<b>Subject:</b>  UNUSUAL NOISE FROM EXHAUST PIPE SEAL RING	<b>Bulletin No:</b> 01-016/12
	<b>Last Issued:</b> 10/19/2012

- This bulletin supersedes the previous bulletins 01-016/12 issued 04/27/12 and 06/27/12, 01-022/11 issued 06/07/11, 01-044/10 issued 08/06/10, 08/13/10, and 10/15/10, and 01-052/08 issued 11/26/08. The REPAIR PROCEDURE and PARTS INFORMATION have been revised.
- Changes are noted below in Red beside the change bar.

2009-2012 Mazda6 2.5L with automatic transmission

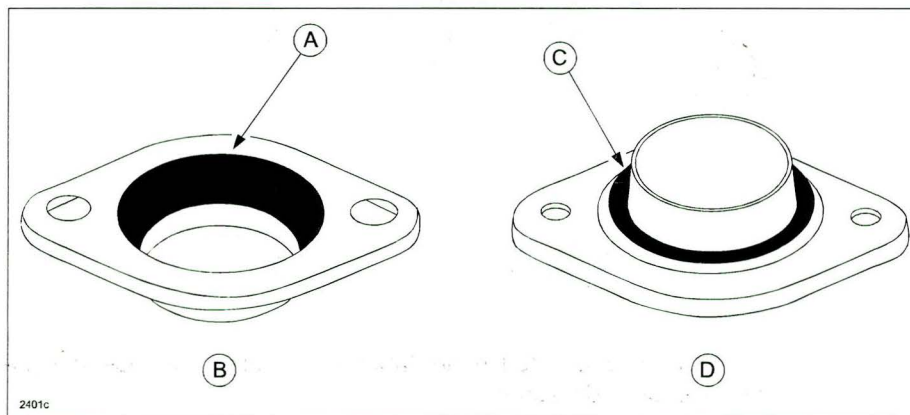
Due to engine vibration and a lack of seal ring lubrication, the mesh in the seal ring (A) rides in the flared portion (B) of the catalytic converter (C) resulting in a slight noise from the exhaust system while the engine is running. **The friction between the exhaust system parts and the resulting slight noise are normal.** This friction does not cause breakage, gas leakage, or other functional problems with the vehicle's exhaust system.

6. Stuff a cloth into exhaust manifold and catalytic converter to prevent dust or debris from entering.
7. Polish the flared portion (A) of catalytic converter-side (B) using a nylon brush or sandpaper (#60) for twenty (20) minutes, then use (#600) for three (3) minutes until bare metal is exposed.

8. Degrease (A) using ethanol for thirty (30) seconds.
9. Remove stains from the seal ring installed location (C) in exhaust manifold (D).
10. Degrease (C) using ethanol for thirty (30) seconds.

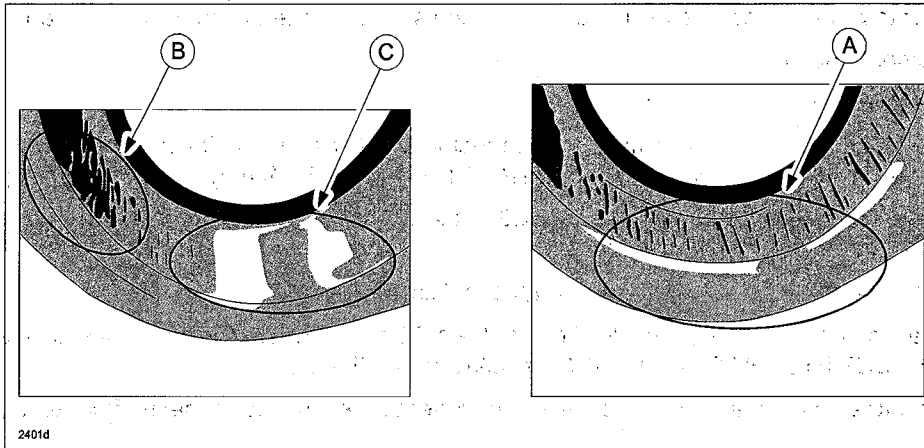
12. If severe damage appears on round surface of catalytic converter-side flared flange (A), replace catalytic converter.

NOTE: If the catalytic converter is replaced and a black coating (B) remains on the round surface of the flared flange, the white coating of the seal ring will stick to the black coating, which may cause noise. Be sure to sufficiently polish the flange (C).

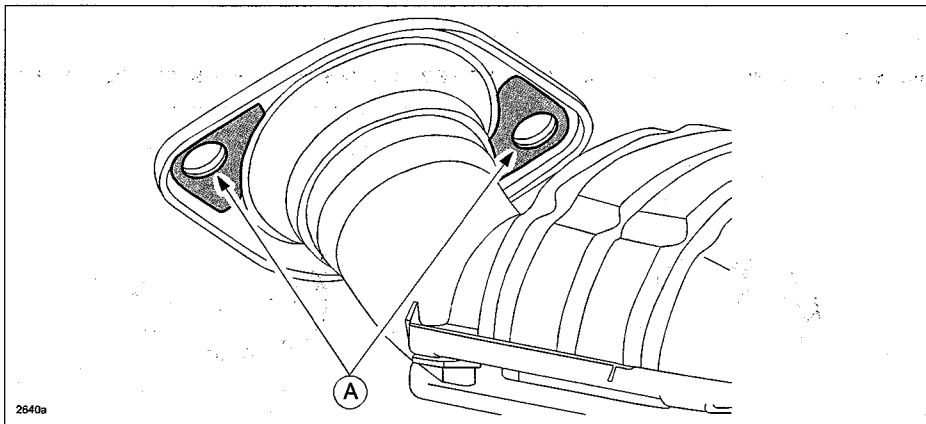
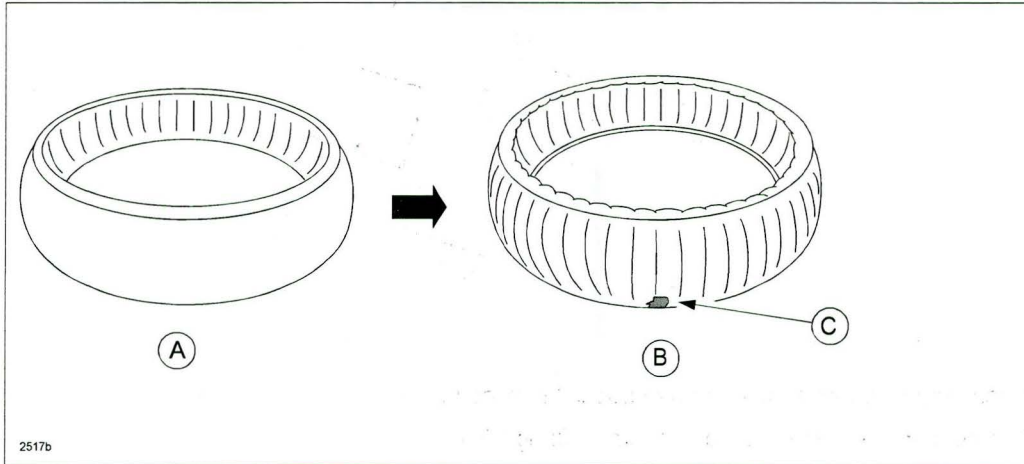
- In case where catalytic converter is NOT replaced:
  - a. Install a new exhaust stud.
  - b. Confirm if patch (A) exists behind the catalytic converter flange.

If YES (patch exists) - Install washer listed in the Part(s) Information to reduce spring tension.

NEVER use an originally equipped washer.

If NO (patch does not exist) - Washer installation is NOT necessary.

Part Number	Description	Qty.	Notes
L555-40-581	Seal Ring	1	Improved part
L3M7-40-584	Stud	2	2
9XB0-09-9201	Washer	2	<ul style="list-style-type: none"> <li>• New washers are used to reduce spring tension.</li> <li>• Necessary only if the original catalytic converter is reused and a patch is welded behind the flange.</li> </ul>
L5Y8-20-55XA	Converter	1	FED. / CANADA / MEXICO
L5Z1-20-55XA		1	CALIF.

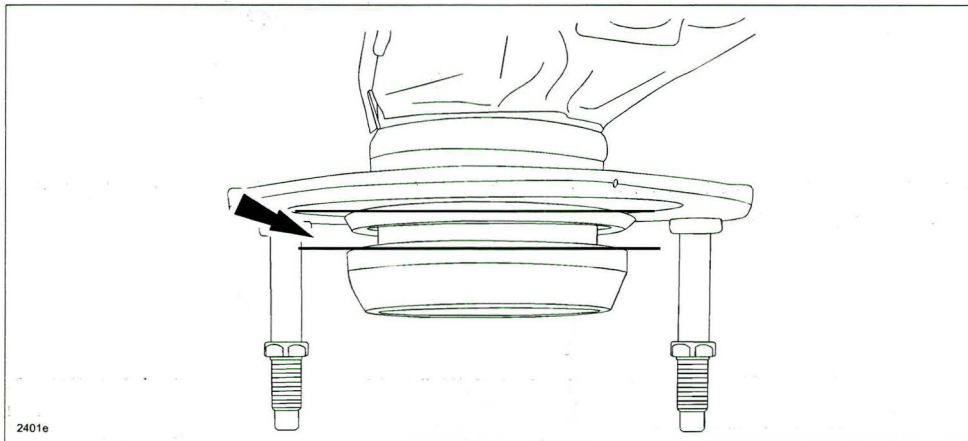
15. Replace old seal ring (A) with new seal ring (B). Push new seal ring (with green identification marking (C)) onto manifold flange by hand.

- Make sure seal ring fits straight and does not fall off when you remove your hand from the ring.
- Make sure seal ring fits straight, if not, there is a possibility the lubrication on the inner surface will be damaged when the seal ring is press-fitted with the special service tool.

**CAUTION:** DO NOT APPLY any type of grease to the seal ring as it will harmfully effect the lubricant performance originally applied on the seal ring and the noise will recur.

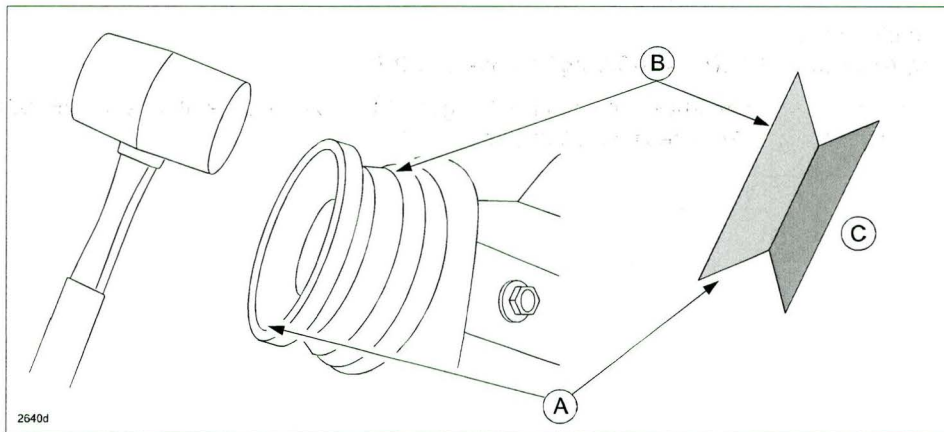
- b. If the gauge can be inserted more than 5mm in one or more locations, perform the following:
1. Place the used original seal ring (A) upside down to the new seal ring (B).
  2. Tap it around carefully against the exhaust manifold (C) with a rubber hammer so as not to damage the seal ring.
  3. Do this until the 0.3mm thickness gauge stops at 5mm or less.

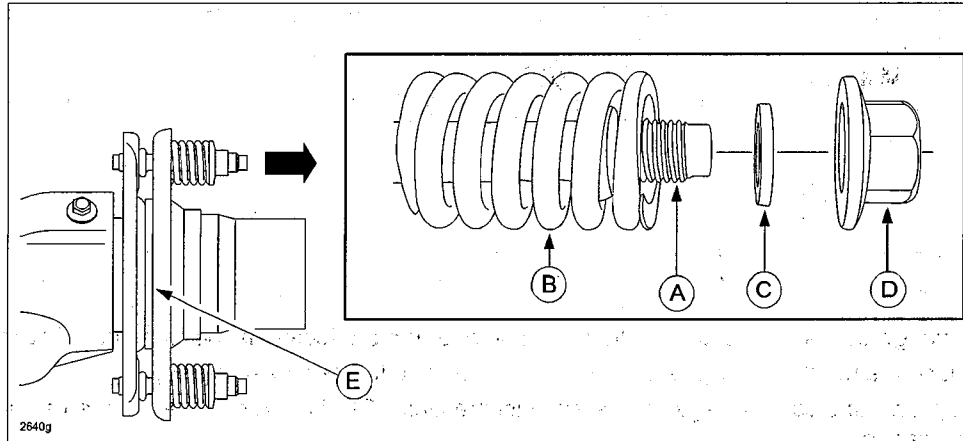
21. Install springs, washers (when necessary according to Step 11), and hex nuts in order.

- A - Exhaust Stud
- B - Spring
- C - Washer - (washer fits inside spring against stud shoulder)
- D - Hex Nut
- E - Seal Ring

**NOTE:** It is NOT necessary to install washers when the catalytic converter is replaced with a new one.

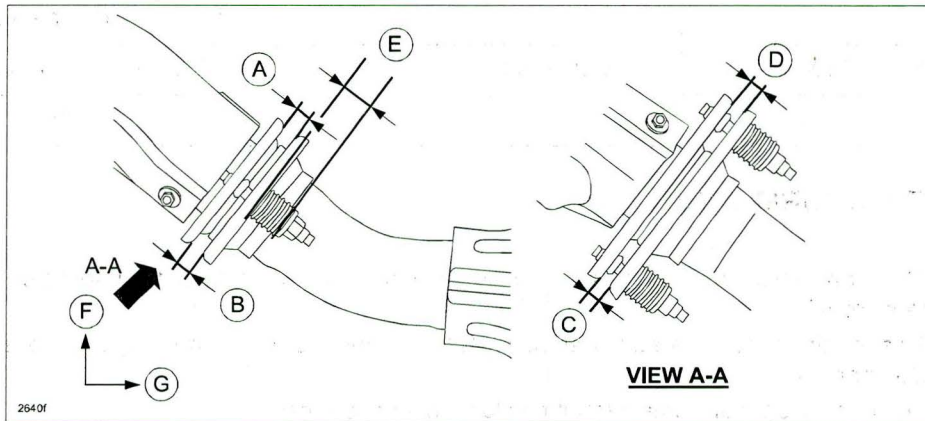
23. Measure the length and clearance between the flanges of the exhaust manifold and U/F catalytic converter. Verify that they are within the specification shown.

A	Upper	9-12 mm
B	Lower	7-10 mm
C	Right	6-9 mm
D	Left	6-9 mm
E	Spring length (end-to-end)	29-31 mm
F	Vehicle upper	
G	Vehicle lower

**NOTE:** If the clearance or spring length is out of range, verify the cause and repair.
